MEMO

To: Kristopher Byrd, Well Construction and Compliance Section Manager
From: Travis Kelly, Well Construction Program Coordinator
Subject: Review of Water Right Application G-19015
Date: December 7, 2020

Groundwater Application Review Summary Form

Application # G- 19015

PLANE 71047

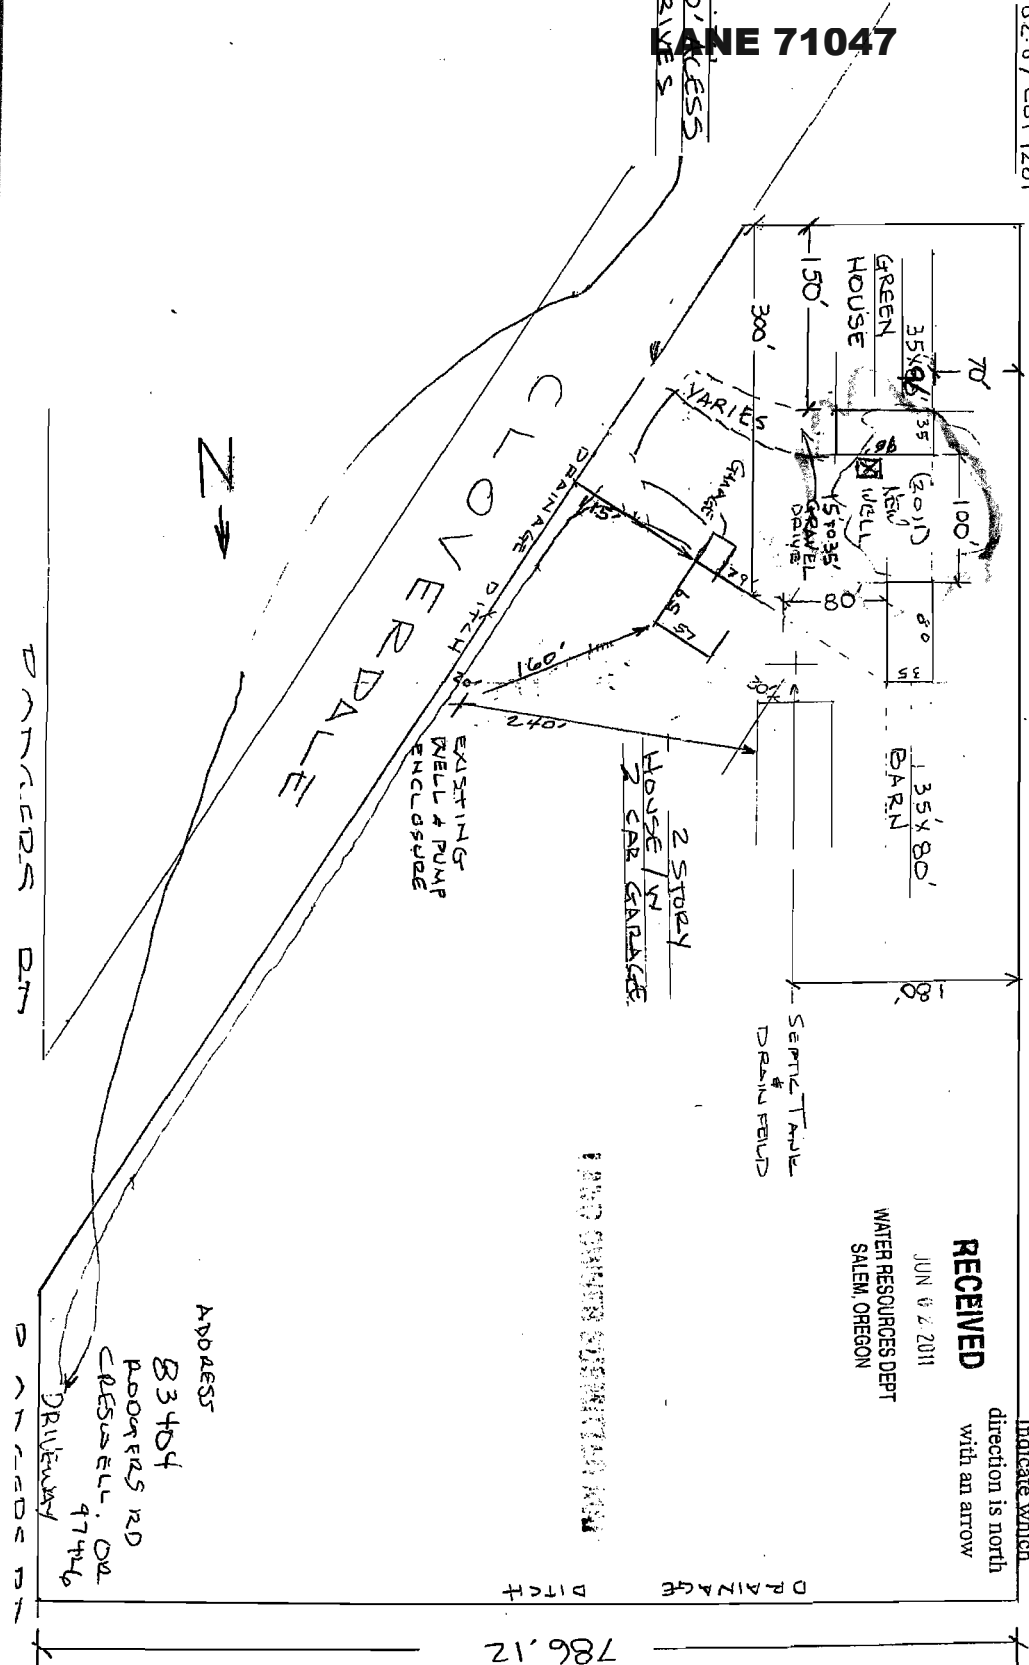
Applicant's Well #2 (LANE 71047): Based on a review of the Well Report, Applicant's Well #2 seems to protect the groundwater resource.

The construction of Applicant's Well #2 may not satisfy hydraulic connection issues.
